DESIGN <i>RF</i>	DRAWN BY <i>TF</i>	DART AEROSPACE LTD HAWKESBURY, ONTARIO, CANADA	
CHECKED <i>HF</i>	APPROVED <i>HF</i>	DRAWING NO. DSI 9295	REV. A SHEET 1 OF 1
DATE 05.03.04		TITLE 206 CABIN HEATER MODIFICATION	SCALE NTS
A	05.03.04	NEW ISSUE

DART SERVICE INSTRUCTION

TO AMEND DRAWING D206-570 REV. C OR D

EXISTING INSTALLATION**MODIFIED INSTALLATION**

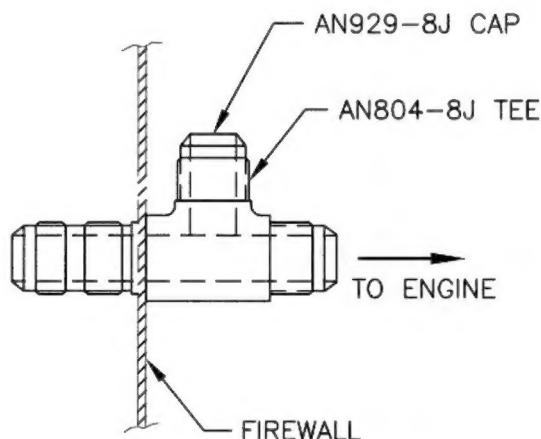
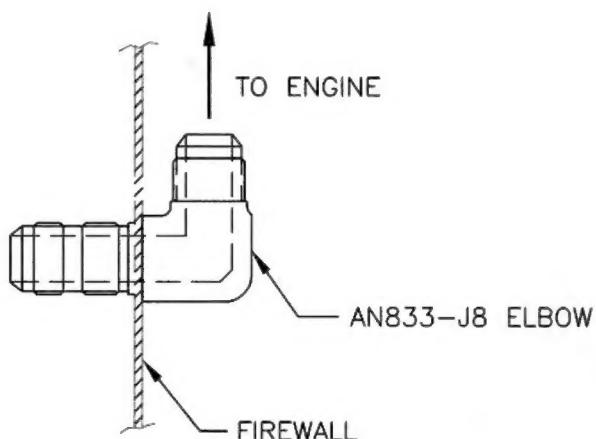
FOR AIRCRAFT THAT HAVE BEEN MODIFIED PER TB 206-81-55 TO MOUNT 222-366-621-003 FILTER ON BACKSIDE OF FIREWALL USING 206-703-002-101 RETROFIT KIT, IT IS ACCEPTABLE TO REPLACE THE AN804-8J TEE FITTING AS SHOWN ON PAGE 4 OF D206-570 WITH AN AN833-J8 ELBOW AS SHOWN ABOVE.
